Access Compliance Report

Public Rights-of-Way

(Curb Ramps)

Intersection ID: N/A	Main Street: INVERNESS_BAY_RD	Cross Street: OBAN_PASSAGE_DR	Location: NE
ADA ID: 5AE35F2D01C8	Ramp Type: Perp	Initial Pass/Fail: Fail	Overall Compliance: No
Codes/Mitigation Info/Possible Solution		Field Measurements/Component Compliance	
Severity Score: 21.25

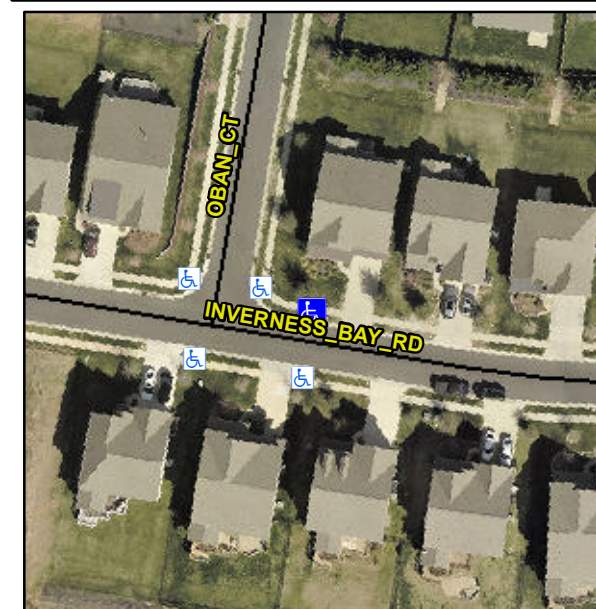
Not Found, R304.5.1, R304.5.3

Compliance	Description	Data	Compliance	Description	Data
N/A	Ramp Length (in)	44.5	Yes	Ramp Slope (%)	7.7
No	Ramp Width (in)	47.5	No	Ramp XSlope (%)	5.6
N/A	Flare Type LT	N/A	N/A	Flare Type RT	N/A
N/A	Flare Slope LT (%)	N/A	N/A	Flare Slope RT (%)	N/A
N/A	Flare Traversable LT?	N/A	N/A	Flare Traversable RT?	N/A
N/A	Landing Length (in)	N/A	N/A	DWS Provided?	N/A
N/A	Landing Width (in)	N/A	N/A	DWS Contrast?	N/A
N/A	Landing Slope (%)	N/A	N/A	DWS Length (in)	N/A
N/A	Landing X Slope (%)	N/A	N/A	DWS Full Width?	N/A
N/A	Landing Curb? (Y/N)	N/A	N/A	DWS Offset (in)	N/A
N/A	Shared Landing?	N/A			
N/A	Gutter Ponding?	N/A	N/A	Gutter Slope (%)	N/A
N/A	Gutter Lip Ht (in)	1.0	N/A	Gutter X Slope (%)	N/A
N/A	Painted X Walk1?	No	N/A	Painted X Walk2?	N/A
	X Walk 1 Direction	To SW		X Walk 2 Direction	N/A
N/A	X Walk 1 Width (in)	N/A	N/A	X Walk 2 Width (in)	N/A
	X Walk 1 Slope (%)	3.8		X Walk 2 Slope (%)	N/A
	X Walk 1 X Slope (%)	4.5		X Walk 2 X Slope (%)	N/A

Remove & Replace Entire Ramp.
